REMARKS

Version with markings to show changes made to the claims

FIG 1

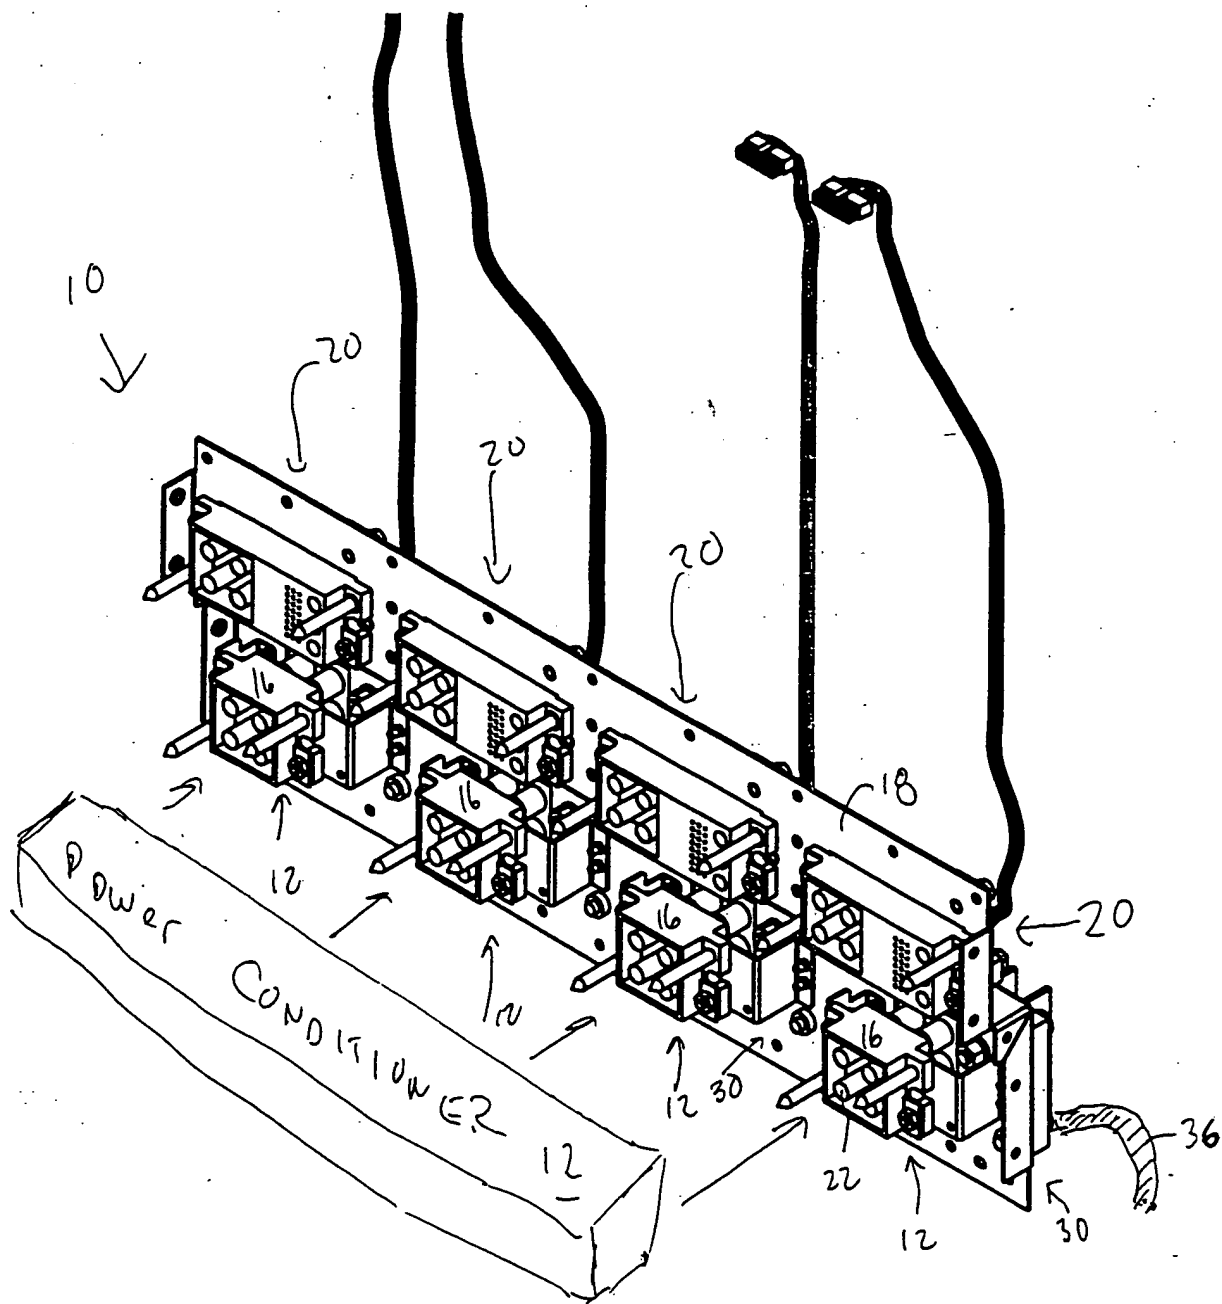
The Examiner has objected to the drawings because the power wire in Claim 7 is not shown in the figures. Respectfully, figure 1 shows the power wire 36. It appears that the "6" of "36" was cut off in copying the figure. An amended figure, with the amendment shown in red, is included. Formal drawings will be provided when the application is allowed.

The Examiner has objected to the drawings because it is unclear to the Examiner exactly what element the lead lines and arrows are pointing to. The figures have been amended, with amendments shown in red, to obviate this objection. Formal drawings will be provided when the application is allowed.
